VILLAGE AT WESTERLY CREEK PHASE 3

DEVELOPMENT APPLICATION

1ST SUBMITTAL	16-0909
2ND SUBMITTAL	16-1213
3RD SUBMITTAL	17-0119
4TH SUBMITTAL	17-0217
5TH SUBMITTAL	17-0317
6TH SUBMITTAL - MYLARS	17-0801
MINOR SITE PLAN AMENDMENT	18-0214

SHEET TITLE:
SITE DETAILS - TRASH ENCLOSURE, TYPE 01

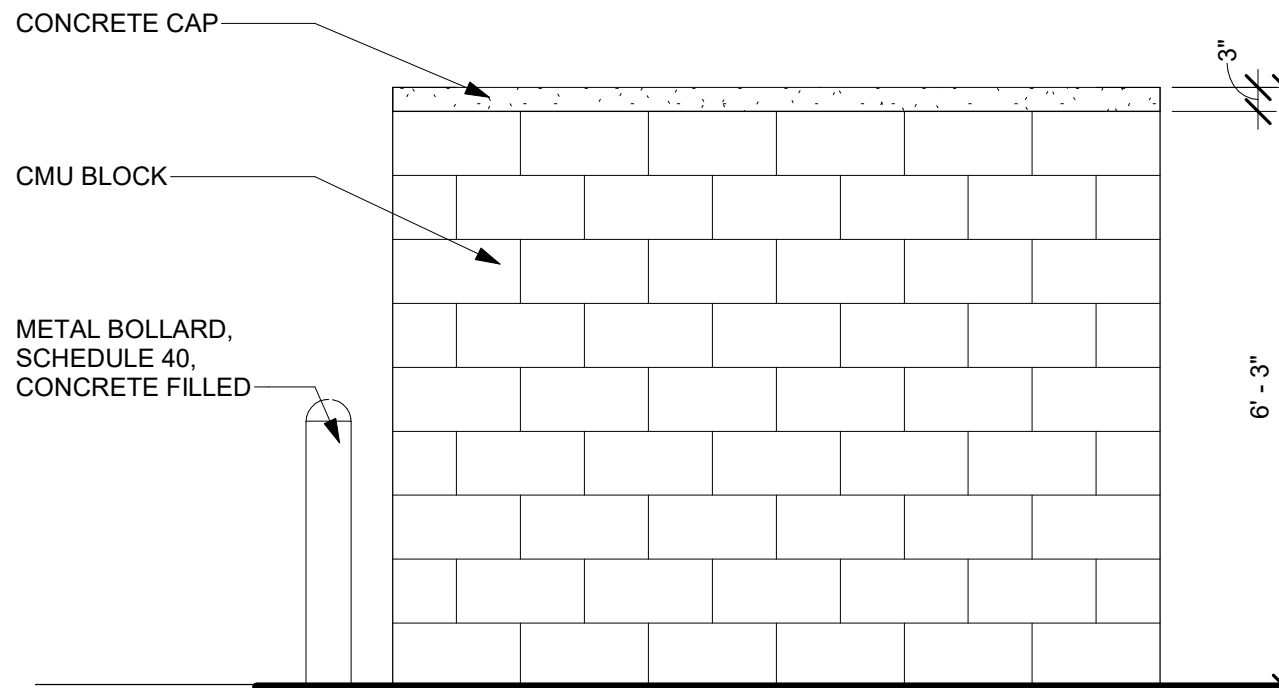
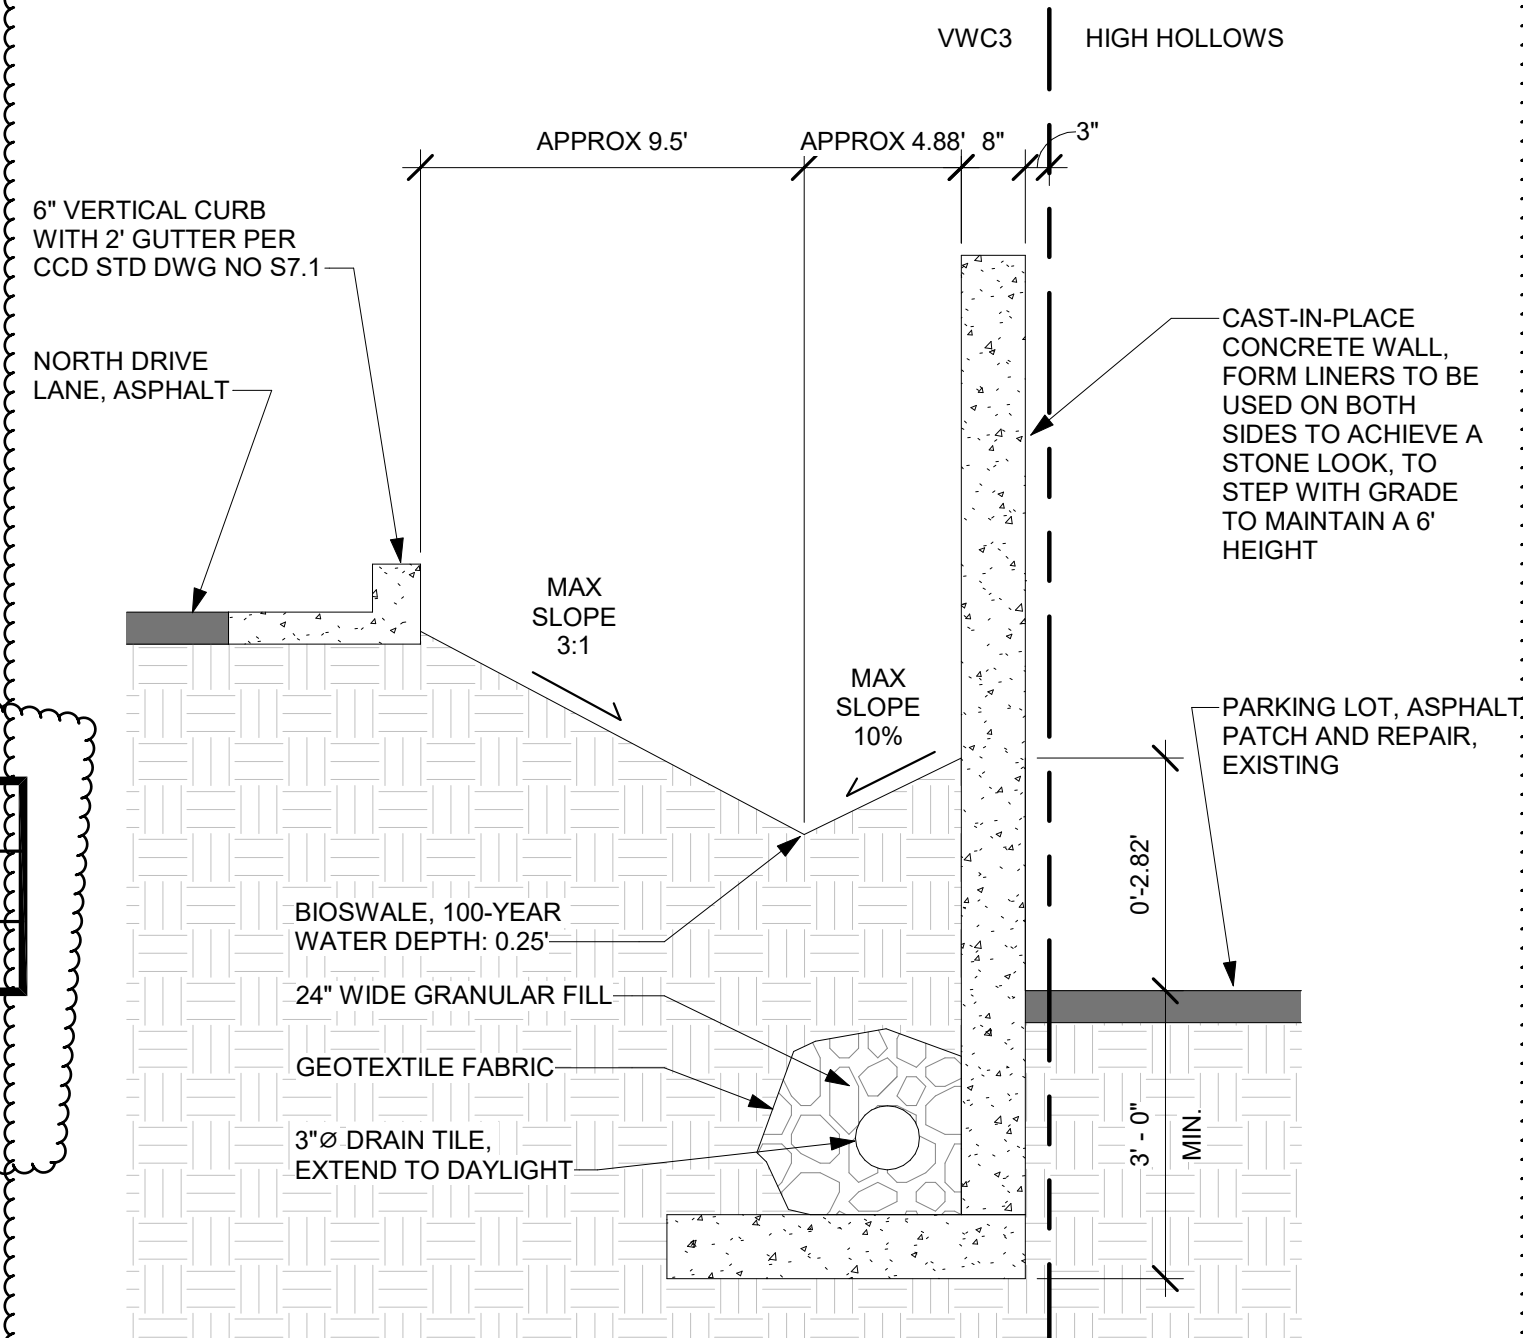
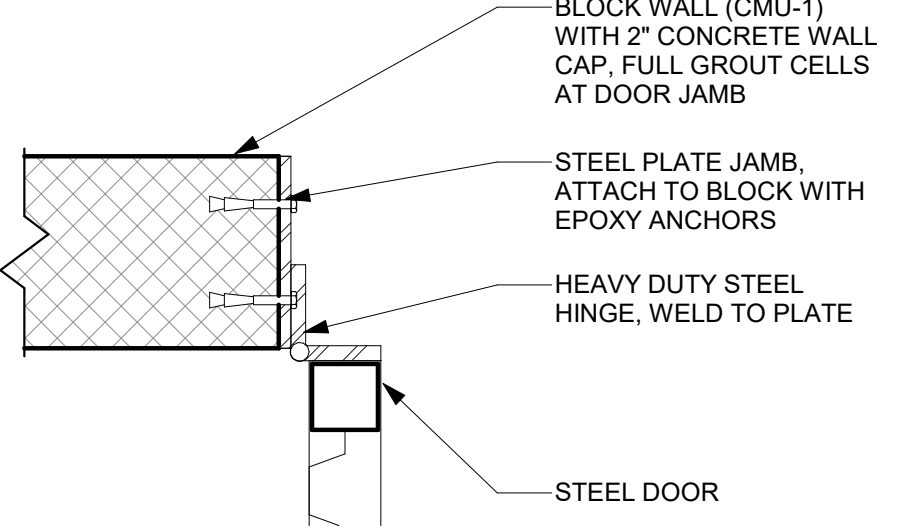
1 SITE FENCE MATERIAL REVISED. SECTION DETAILS ADDED.

SHEET TITLE:
LANDSCAPE CALCULATIONS
SHEET NO:
L-02
SHEET 9 OF 36

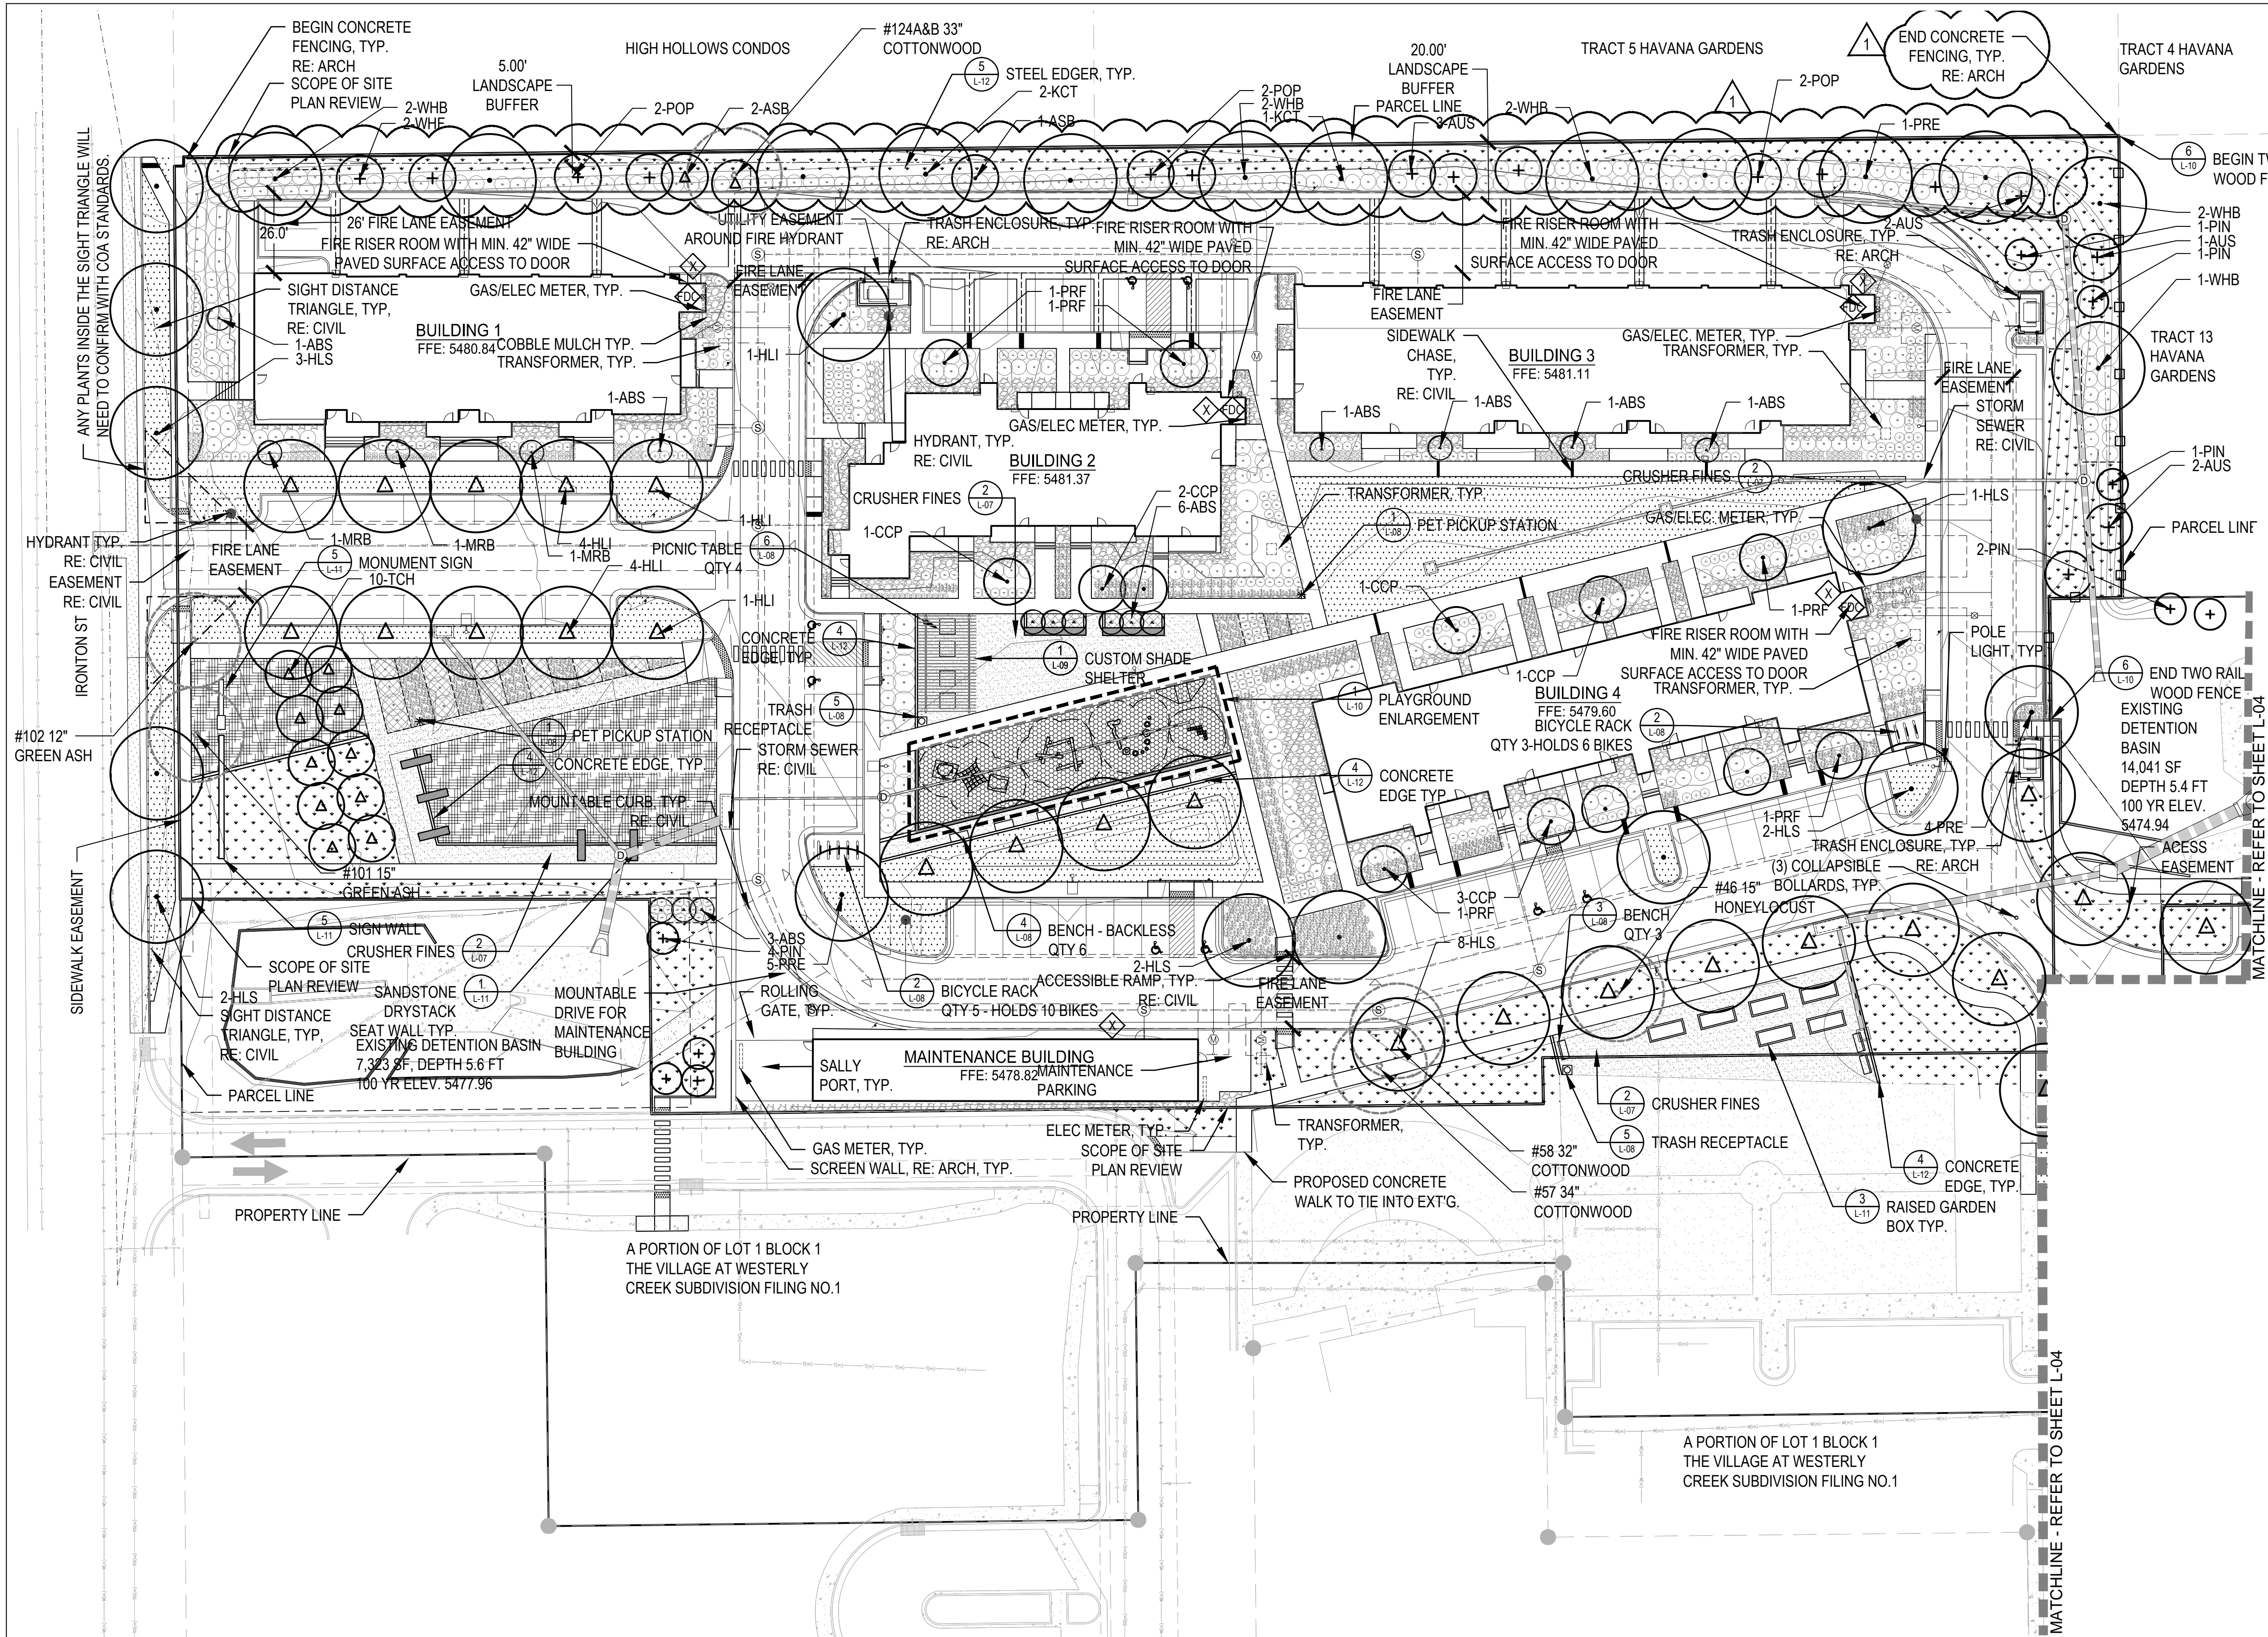
1 PLANTING RELOCATIONS AND SITE WALL FENCE LENGTH REVISION

LANDSCAPE PLAN

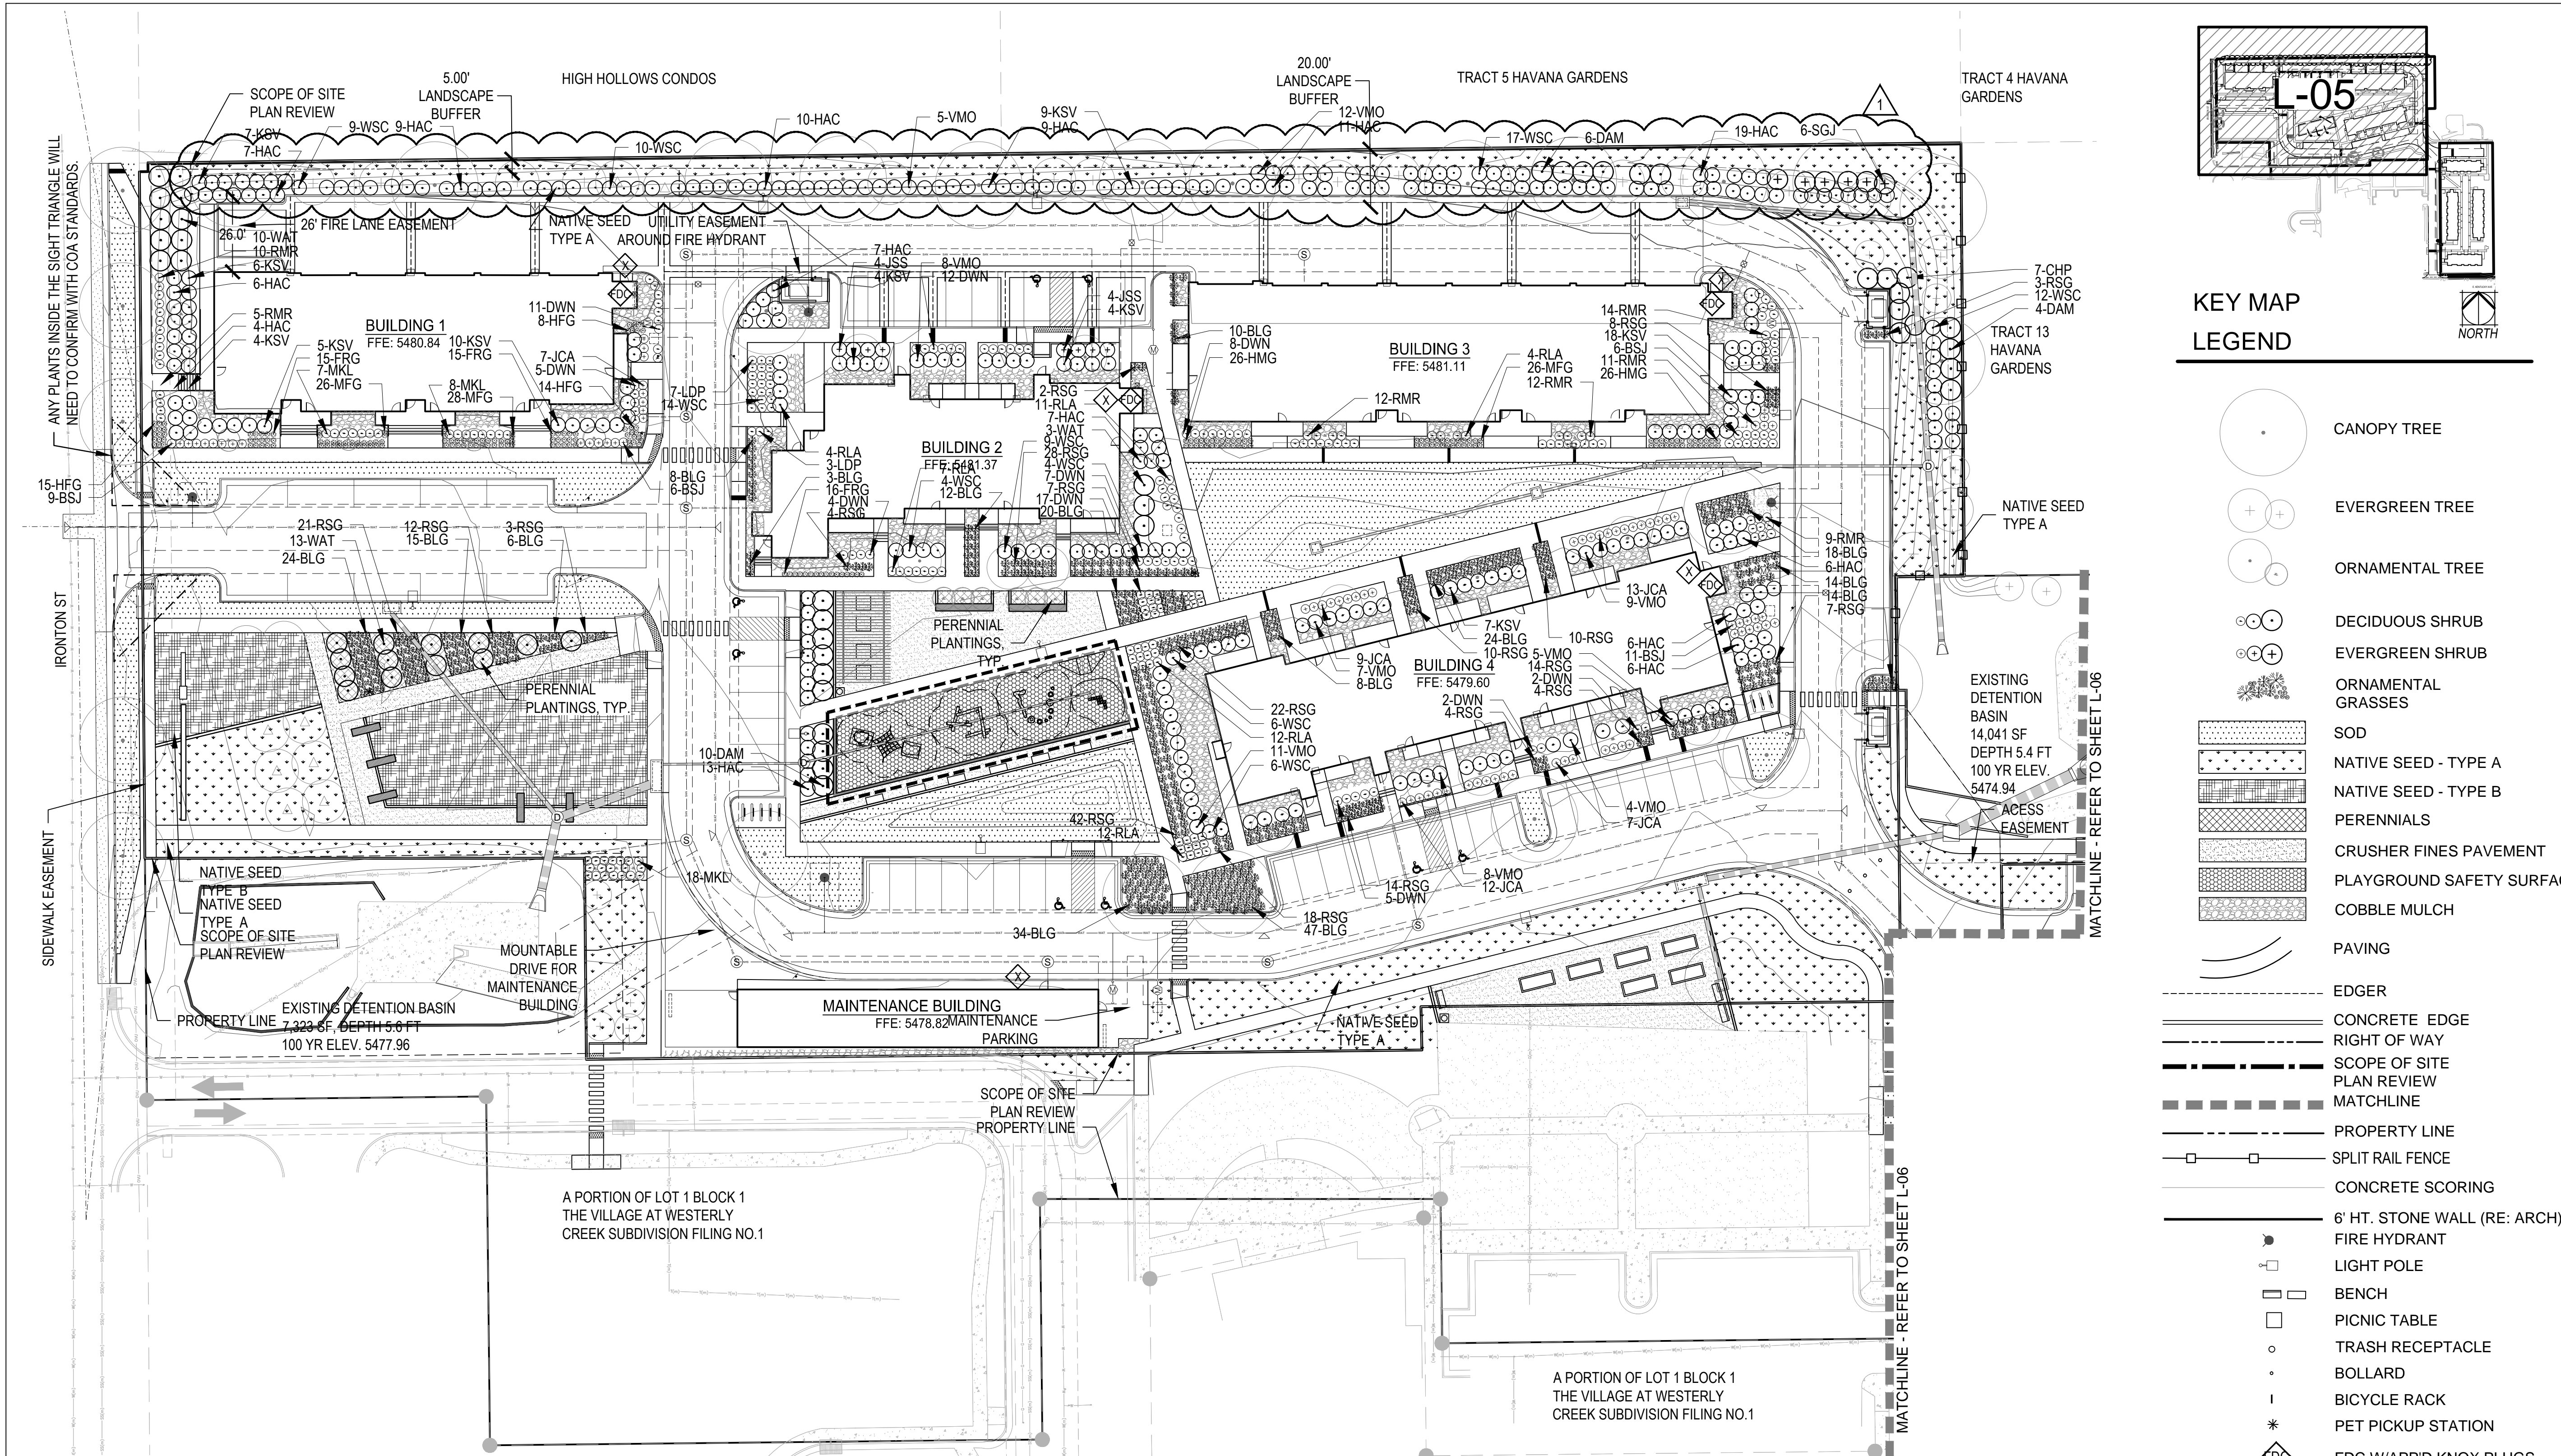
1 PLANTING RELOCATIONS AND SITE WALL FENCE LENGTH REVISION
